AQUATIC ASSESSMENT OPINION HIGHLANDS NORTH WIND ENERGY FACILITY (WEF): PROPOSED AMENDMENTS TO THE ENVIRONMENTAL AUTHORISATION (DEFF REF: 14/12/16/3/3/1/1955)

EnviroSci (Pty) Ltd was appointed to review the proposed amendments to the project description and layout amendments against the previous aquatic impact assessment submitted in 2018/2019, noting that the Aquatic Impact Assessment was compiled by the same lead author as the undersigned.

FIGURE 1: Amended project layout (red lines), when compared the observed watercourses with 32m buffer.

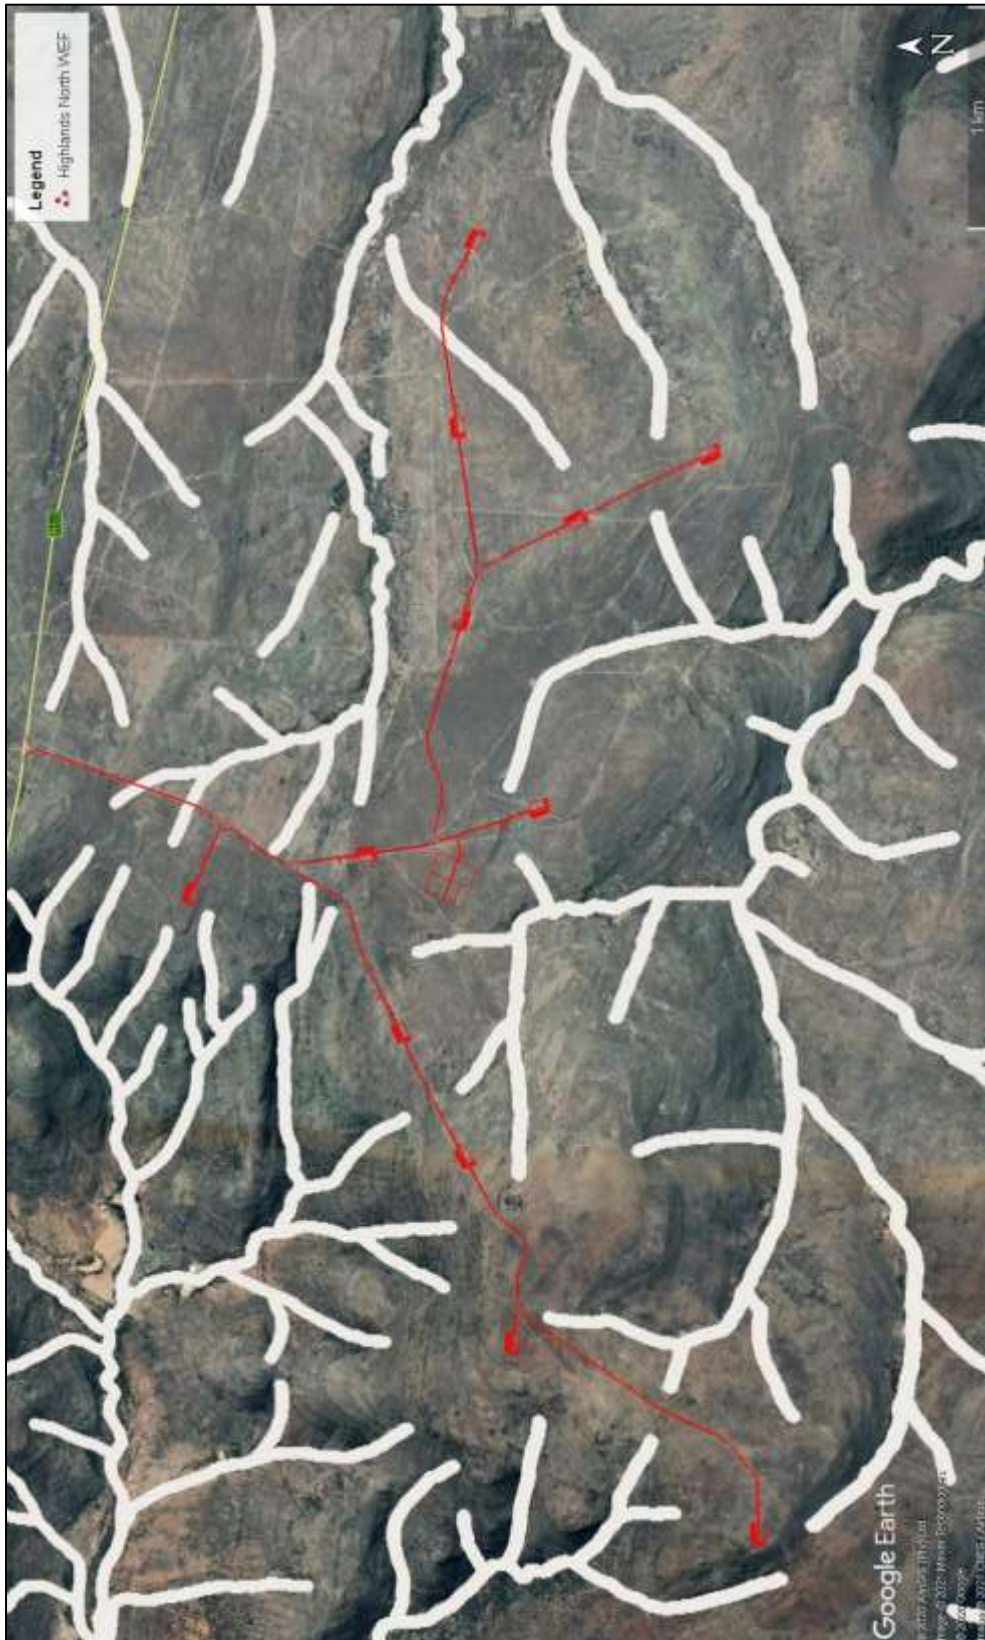
Table 2, summarises the findings of the impact assessment comparison between the authorised and amendment layout (Figure 1). As the impacts and their significance (with and without mitigation) were similar the reversibility, irreplaceability, extent, duration, severity, probability and status also remains unchanged, thus Table 2 only indicates the overall significance.

The proposed increased size of the turbines and increased footprint (of the turbine foundations and hardstandings) has had no direct impact on the aquatic environment, as the overall changes are mostly vertical (increases in height), which necessitated a change in the road layout (due to the reduction in the number of turbines), but more importantly the positions and changes to the associated infrastructure still avoid the most sensitive areas of the delineated aquatic zones including their respective buffers. This includes the proposed Battery Energy Storage System.

In conclusion, the potential impact of the proposed amendments and amended layout on the aquatic environment will remain unchanged from the original impact assessment if all the proposed mitigations are upheld. There is however an overall advantage to the proposed layout as the overall number of watercourse crossing has been reduced, although the impact significance would remain LOW for all the impacts.

Thus, based on the findings of this study, no objection to the authorisation of any of the proposed amendments, assuming that all mitigations proposed in the reports submitted are carried out. Similarly, in the assessment of potential cumulative impacts, no additional impacts or changes to the previously assessed impacts would be required due to the proposed amendments.

No changes to the original mitigations or EMPr considerations are required.
